**STAFF REPORT**  
**COMMUNITY DEVELOPMENT DEPARTMENT**

HEARING DATE: 11/17/2020  
 TO: Mayor & City Council  
 FROM: Joe Dodson, Associate Planner  
 208-884-5533  
 Bruce Freckleton, Development Services Manager  
 208-887-2211  
 SUBJECT: H-2020-0006  
 Teakwood Place Subdivision  
 LOCATION: The site is located at 1835 E. Victory Road, approximately ¼ mile east of S. Locust Grove Road, in the NW ¼ of the NW ¼ of Section 29, Township 3N., Range 1E.

Annexation & zoning of 7.35 acres of land with an R-8 zoning district and preliminary plat consisting of ~~28~~ 22 building lots and 4 common lots, by Hesscomm Corp.

B. Preliminary Plat (date: 3/25/2020/24/2020 8/12/2020)

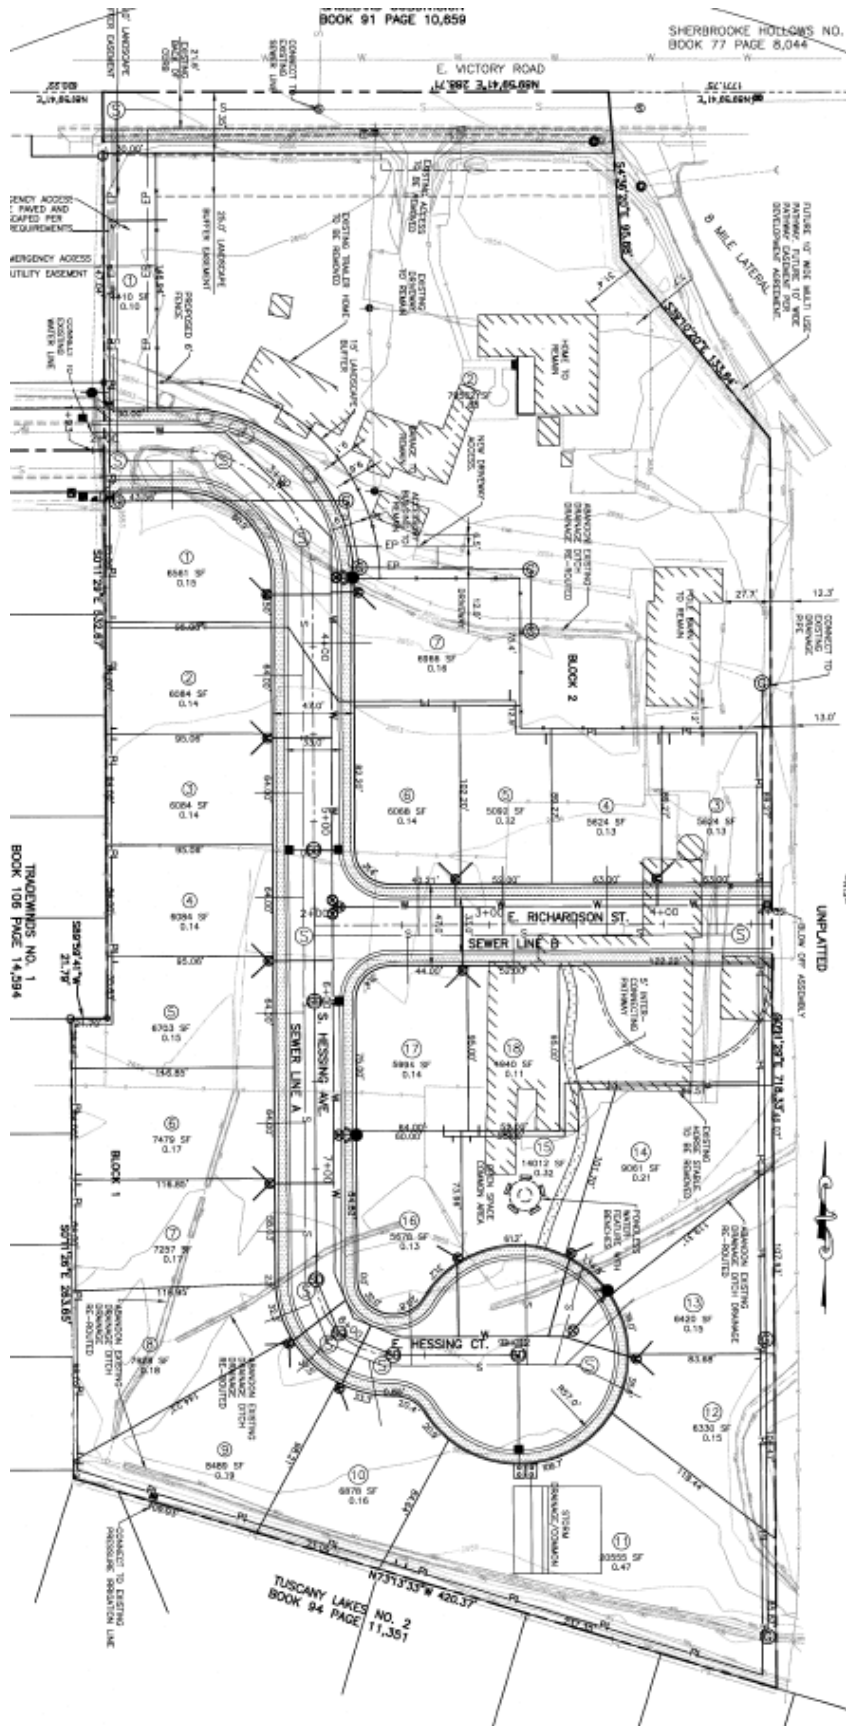
***Staff is not supportive of the phasing plan as proposed. Staff recommends the development be constructed in one phase and the applicant amend the plat to include the existing residence on a lot and block in the subdivision and require the home connect to city utilities with a new access to the proposed extension of E. Fathom Street OR remove all of the existing structures identified in phase 2 and develop the four additional lots as proposed.***

***The owner is proposing requesting to keep the driveway for the existing home onto E. Victory Rd. which does not comply with ACHD district policy or the City's UDC City code (UDC 11-3A-3). However, in the received staff report from ACHD, they have amended their policy to approve of maintaining this access and site the low number of vehicle trips from one home. Staff does not support keeping an access to Victory Road when a lesser classified street is available for access. Staff believes that if the existing access does not close at the time of this development, it may never be closed.***

One of the revisions made by the applicant is changing the type of cul-de-sac proposed in the south end of the development. The new plan shows a larger cul-de-sac that has a 57-foot radius. The larger radius turnaround allows an additional 9-feet of pavement in the cul-de-sac which then allows on street parking. The perimeter of the cul-de-sac that can be parked on (perimeter minus driveway curb cuts) is now approximately 200 feet which can accommodate approximately 8 on street parking spaces. The true amount of cars that could be parked within the cul-de-sac is wholly dependent on the size of the vehicles being parked. Therefore, Staff's estimates are based on general calculations and include the UDC noted parallel parking space dimension of 23-feet long. Some vehicles may take up more or less than this value.

The revised plat also shows some of the non-qualifying open space on Lot 19, Block 1 which is the lot with the temporary turnaround located on it. The Applicant has deemed this lot as non-buildable until the stub street is extended and the temporary turnaround is removed with a plat note. Staff agrees with this designation but making it non-buildable and including it in the overall open space depicts a potential issue in the future. Will this lot be a future common open space lot or will it be a future buildable lot? Staff wants to ensure all of the open space numbers and the number of buildings lots are confirmed prior to this application being developed. In addition, if Lot 19, Block 1 is intended to be a common open space lot in the future, an additional small pocket of open space is not ideal. If this is the intended purpose of this lot, Staff recommends that the Applicant revise the plat to have the proposed open space more contiguous to each other. This can be accomplished by moving the open space on Lot 7, Block 2 to Lot 18, Block 1 and then converting the adjacent Lot 15, Block 1 into a common open space lot. That would create a central greenway from the south of the property to the east-west stub street in the center of the development and connect to the future open space lot that holds the temporary turnaround. This option would also offer more common open space than the minimum. If this is not the intended use for Lot 19, Block 1, the Applicant should revise the open space exhibit to remove the area of this lot from all open space calculations.

After removing redundant open space and the paved areas on the common open space lots, Staff calculates approximately 29,634 square feet (or .68 acres, 9.25%) of qualified open space which is below the minimum required 10%. Staff removed the area for the temporary cul-de-sac proposed on one of the common open space lots and the 30 foot wide emergency access easement area from the open space calculation.

In addition, if the required temporary turnaround is flipped and placed on one of the adjacent buildable lots to the south of the large common lot (i.e. lots 21 or 22), more open space would be available to the residents in this subdivision. Staff recommends this change because there is little guarantee to the City that the property to the east will ever develop and therefore little guarantee the temporary cul-de-sac will not become permanent. Approximately 4,800 more square feet of qualified open space would be added to this project with this recommendation. By following this recommendation and the landscape recommendation regarding the emergency access, approximately 9,200 more square feet of qualified open space would be added, making a total of

- l. All stormwater detention facilities shall be designed to completely drain within a 12-hour period.
2. The preliminary plat included in Section VII.B, and dated ~~03/25/2020~~06/24/2020 ~~8/12/2020~~, prepared by Leavitt Associates Engineers, Inc., shall be revised as follows prior to submittal of the final plat application.

- ~~a. Revise the plat to show the temporary cul-de-sac on the south side of the proposed E. Richardson St., on Lot 21 or 22, Block 1 and add a note stating that said lot is non-buildable until such time as E. Richardson St. is extended.~~

- b. Add a note prohibiting direct lot access via E. Victory Road. Lot 2, Block 2 shall take access from E. Fathom St in accord with UDC 11-3A-3.
  - ~~c. The emergency access on Lot 5, Block 2 shall be constructed prior to any issuance of Certificate of Occupancy.~~

- e. Add an additional common lot along Victory Road to contain the required 25-foot wide landscape street buffer or apply for Alternative Compliance with final plat submittal to request the buffer to be within an easement.

LANDSCAPE PLAN  
SCALE: 1/8"=1'-0"

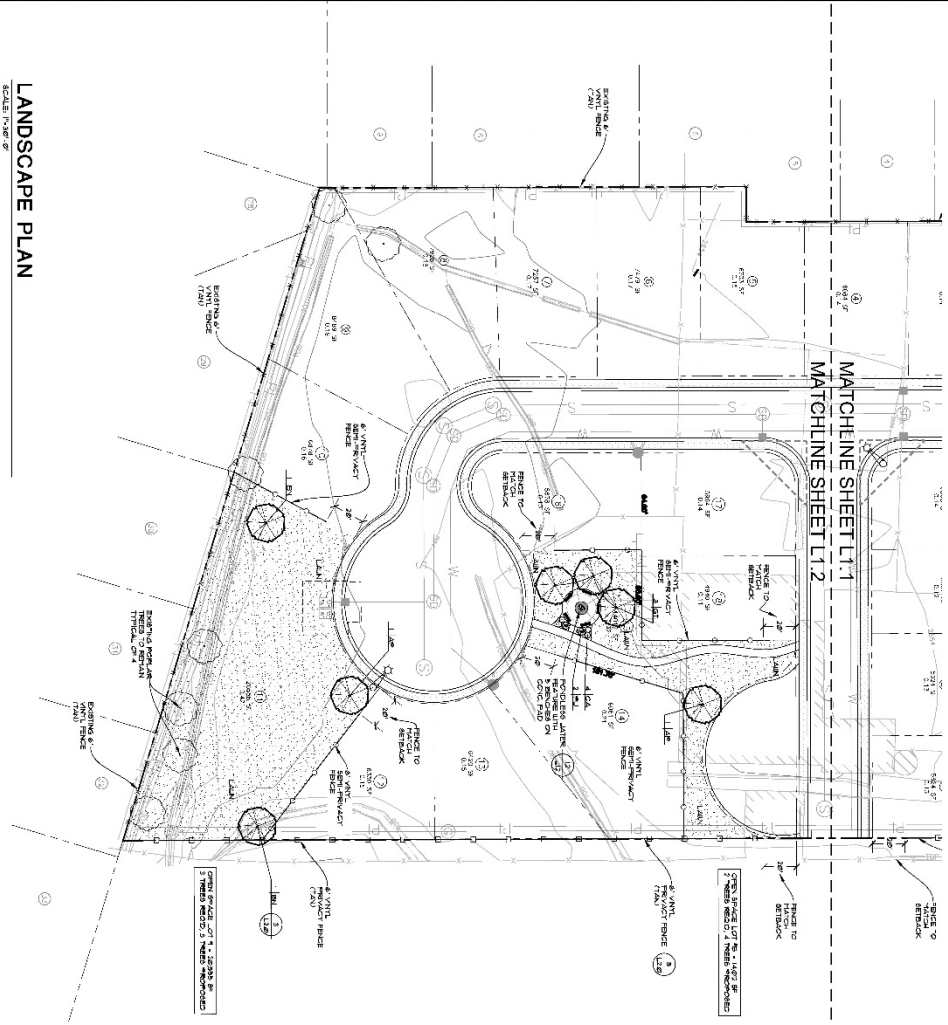
**a condition of approval to place the buffer in a common lot or apply for Alternative Compliance with the Final Plat submittal to place the buffer within an easement.** In addition, UDC requires that trees be spaced at a density of one tree per thirty five (35) linear feet (UDC 11-3B-7C.2). Because the existing trees that are to remain are bunched together on the site, they do not meet this requirement. Compliance with this code section is required and in order to comply, Staff recommends adding two (2) additional trees to the east half of the landscape buffer. These additional trees, spaced correctly, would add to the buffer and help the Applicant meet the landscaping requirements. Furthermore, landscape buffers are also required to be vegetated with shrubs, lawn, or other vegetative ground cover for at least 70% of the area at the time of plant maturity, with mulch used under and around the plants (UDC 11-3B-5N). The landscape plans do not show compliance with this requirement and should be corrected prior to the City Council hearing.

Common open space is required to be landscaped in accord with the standards listed in [UDC 11-3G-3E](#). **The total square footage of common open space should be corrected in the Landscape Calculations/Requirements table along with and the required number of trees to demonstrate compliance with UDC standards is shown in the Landscape Calculations table.**

3. The landscape plan included in Section VII.C, and dated ~~11/20/2019~~6/25/2020 ~~8/13/2020~~, shall be revised as follows at least 10 days prior to the City Council hearing:

- c. ~~The Landscape plan shall be revised to reflect a single phase per the conditions in this report.~~
- d. ~~Revise the Landscape Plan to show landscaping along the emergency access road—common lot 5, Block 2. Said lot shall be developed with a 20-foot wide paved surface and five feet of landscaping on each side in accord with UDC 11-3B-12.~~

- e. ~~Revise the landscape plan to match the newly revised preliminary plat and show the proposed cul-de-sac with a radius of 57 feet and with no parking in the center.~~

- f. ~~Revise the landscape plan to show the required frontage improvements along E. Victory Road and within its own common lot Lot 2, Block 2. This should include at least two (2) more trees on the eastern half of the buffer and the required vegetative ground cover as required in UDC 11-3B-5N and 11-3B-7.~~
